OAK RIDGE NATIONAL LABORATORY

April 27, 1994

In reply to your request that I review the doctoral thesis of Alexander Sich, "The Chernobyl Accident Revisited: Source Term Analysis and Reconstruction of Events During the Active Phase," I found it very interesting but too voluminous to digest fully in a short period of time. I have, however, reviewed the most relevant sections (esp. Chapters VI and VII) and have investigated a few questions. First, the fission product inventory data appear reasonable with one exception: the inventory value for ^{136}Cs appears to be high by at least a factor of 50, as discussed below. Second, considering the uncertainties in much of the data, most of the fission product release values appear to be generally consistent with accepted experimental data for comparable conditions, but the release values for ruthenium and cerium seem very high. Further, the accident scenario hypothesized by Sich in Chapter VII, while requiring considerable stretch of the available data, seems plausible. It does tend to explain the peaks in release rates at day 8.5, a very important point. Perhaps additional information will be forthcoming to clarify his ideas.

Fig. 1. Comparison of ^{103}Ru and ^{137}Cs release data from fallout samples collected throughout Europe a few days after the Chernobyl accident

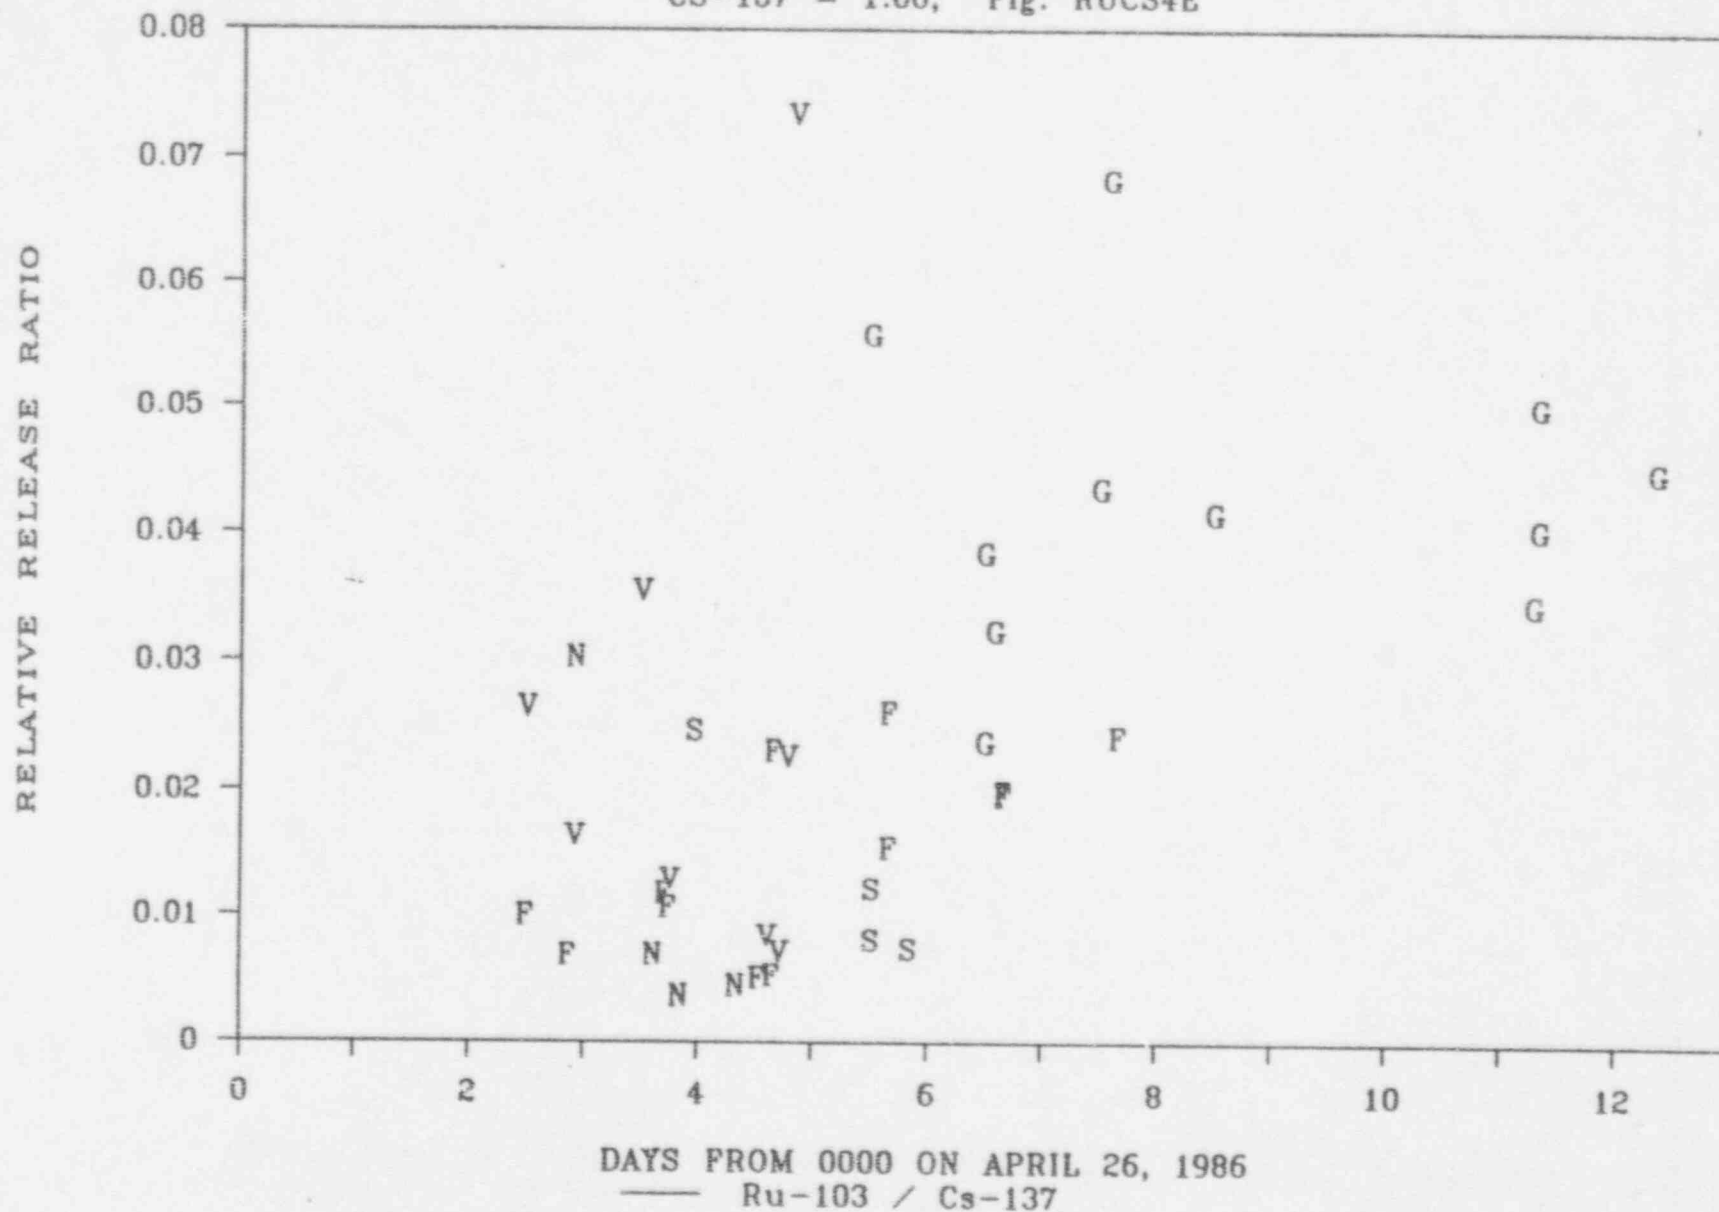
- (a) We see no basis for the 95% release for ruthenium shown in Table VI.15; the 75% value in Table VI.13 is more believable, but also seems quite high. While Hunt, Cox, et al at Chalk River have documented very high ruthenium releases from small samples of UO_2 heated in air, both the much smaller surface-to-volume ratios for the Chernobyl core during the active phase and the fact that some 29% of the core had been dispersed, and, presumably, was at relatively low temperature, would indicate significantly lower release. Furthermore, the analysis of 58 fallout samples collected throughout Europe (from Scandinavia to France to Greece) by Lorenz at ORNL showed that the release of ^{103}Ru to windblown particles was ~2% of the release of the major cesium isotopes (see Fig. 1). In addition, the 95% release value is inconsistent with Sich's data. Comparison of ^{103}Ru data from Tables VI.12 and VI.15 (inventory), using ^{137}Cs as a reference, indicates a ^{103}Ru release of 24% — not the 95% shown in VI.15.

Fig. 2. Cs RELEASE RATE IN TEST VI-2

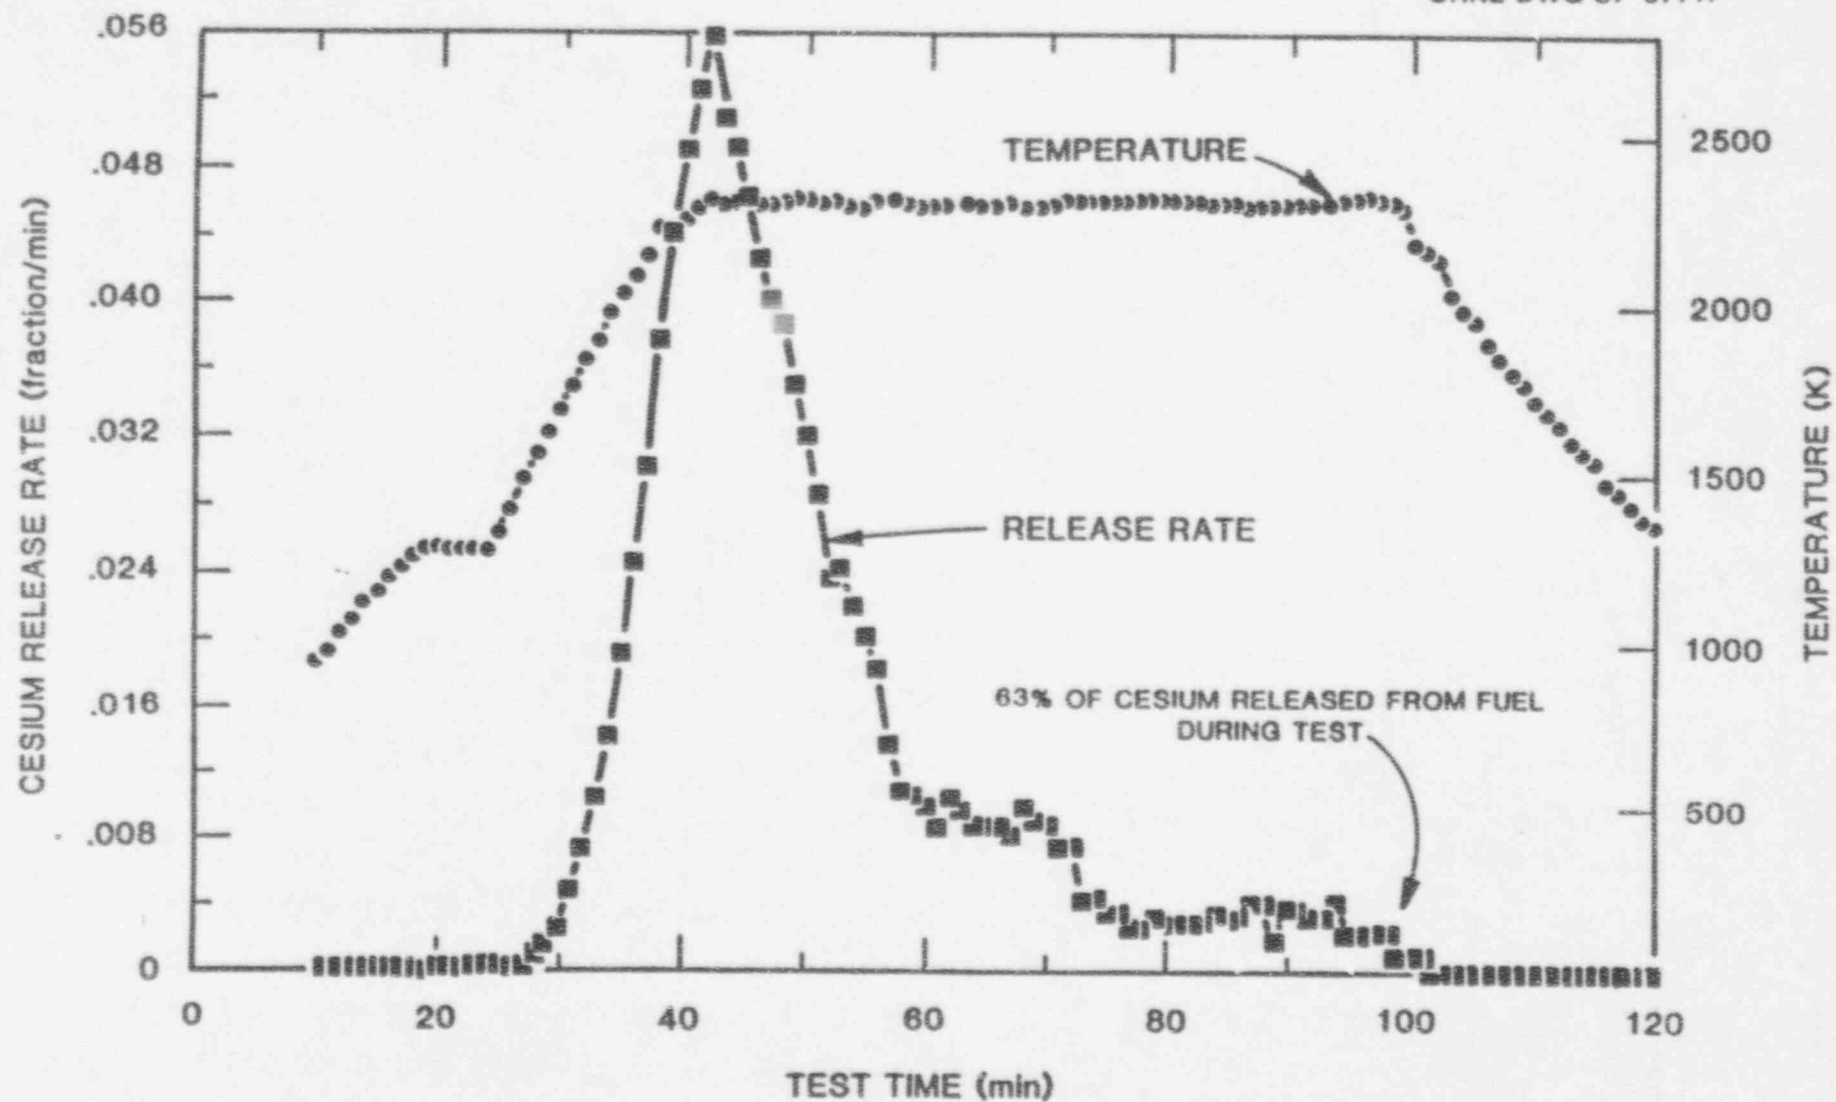
- (c) Although the 65% release of cesium seems low compared to TMI-2 results, there are indications that some cesium form is stable at relatively high temperature. In our test VI-2, a specimen of BR3 fuel was heated in steam at 2300 K for 60 min. At the end of the test, the release rate had declined to a very low level, with a total cesium release of 63% (later revised to 67%), as shown in Fig. 2. If the temperature of the Chernobyl core (that 71% on the lower biological shield) were ~2300 K or less for most of the active phase, such a cesium release fraction seems plausible. In addition, the cesium release from a large part of the 29% of core ejected from the reactor cavity could have been even lower, since temperatures for the smaller masses should have been significantly lower.
